**BROWNS FERRY NUCLEAR PLANT (BFN) - UNITS 1, 2, AND 3 -  
TECHNICAL SPECIFICATIONS (TS) CHANGE TS-418 AND TS-431 -  
EXTENDED POWER UPRATE (EPU) - RESPONSE TO ROUND 16 REQUEST  
FOR ADDITIONAL INFORMATION (RAI) - SRXB-74/86 AND SRXB-87  
THROUGH SRXB-90 (TAC NOS. MD5262, MD5263, AND MD5264)**

**TENNESSEE VALLEY AUTHORITY  
BROWNS FERRY NUCLEAR PLANT (BFN)  
UNITS 1, 2 AND 3**

**TECHNICAL SPECIFICATIONS (TS) CHANGES TS-418 AND TS-431  
EXTENDED POWER UPRATE (EPU)**

**RESPONSE TO ROUND 16 REQUEST FOR ADDITIONAL INFORMATION  
SRXB-74/86 AND SRXB-87 THROUGH SRXB-90**

Figure SRXB-90.3 Bypass Mixture Level  
for .05 FT<sup>2</sup>/PD TOP SF-BATT 102P/105F EPU  
With Bypass Injection of LPCS

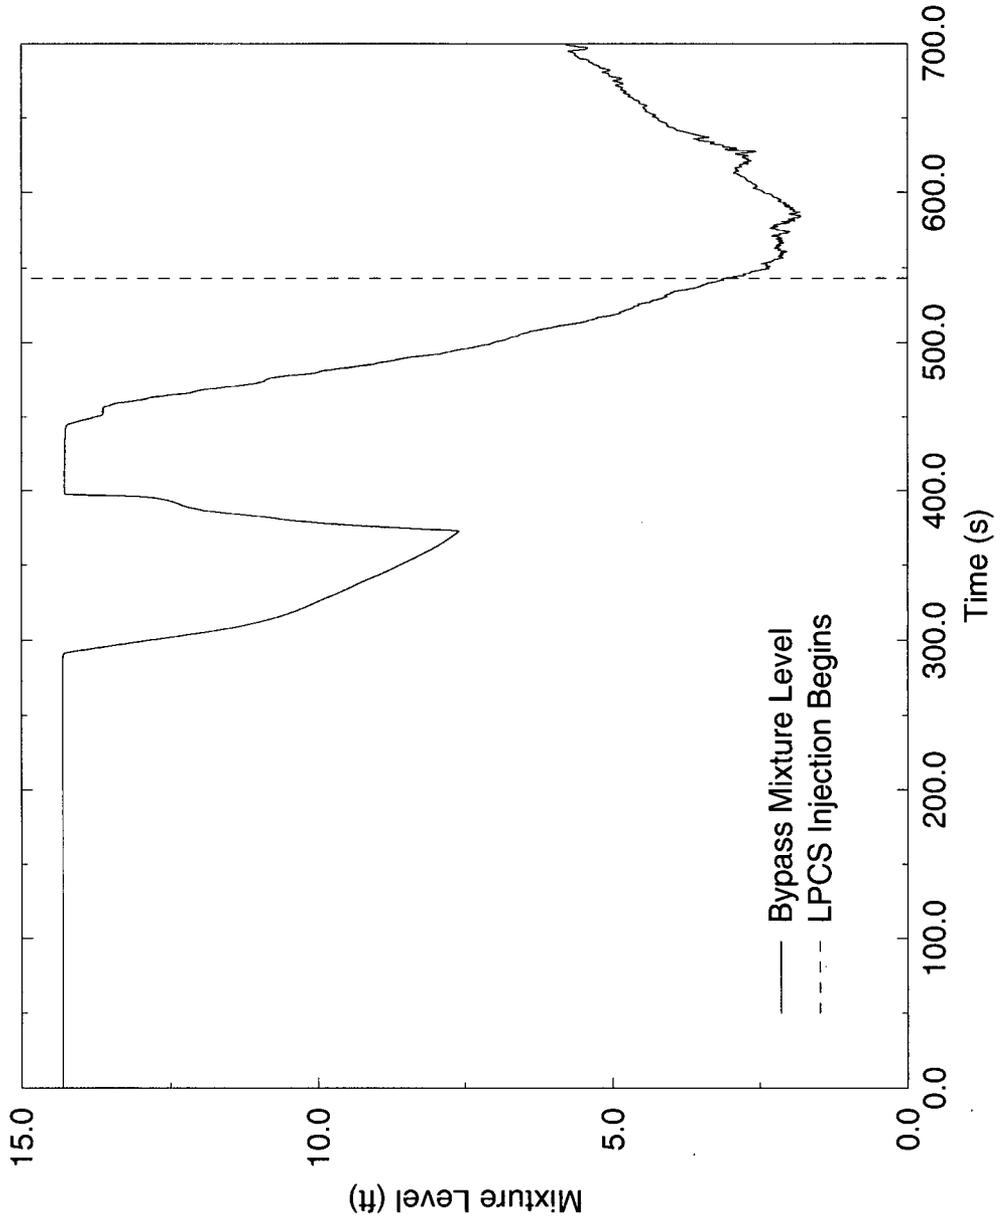
**NRC RAI SRXB-90 (Units 2 and 3 only)**

Provide the following information regarding the AREVA LOCA analyses:

- the flow area above the hot bundle exit,
- power of the hot bundle, and
- perform an analysis assuming little or no downflow.

] Therefore, to accommodate the NRC request, the 0.05 ft<sup>2</sup> top-peaked small break LOCA analysis was repeated with the modification that the injection of Low Pressure Core Spray (LPCS) was moved from the upper plenum (node 1 in Figure SRXB-90.2) to the bypass (node 9 in Figure SRXB-90.2). This allowed for the injection of water from the LPCS, which is needed to refill the lower plenum, without LPCS being available for CCFL into the core. Review of the results confirmed there was no top-down cooling from liquid entering the top of the bundle from the upper plenum after the time when LPCS flow starts (the LPCS did not fill the bypass and then flow into the upper plenum). The peak clad temperature (PCT) for this analysis is 1465°F.

Figures SRXB-90.3 through SRXB-90.5 show that the selected modeling is performing as intended. Figure SRXB-90.3 presents the liquid level in the bypass and demonstrates that some of the injected Emergency Core Cooling System water is held up in the bypass. Thus, all of the LPCS injection does not instantaneously drop into the lower plenum. The figure also shows that the bypass does not fill completely prior to reflood. Therefore, no injected LPCS water can spill into the upper plenum to drive downflow of liquid through the core prior to reflood.
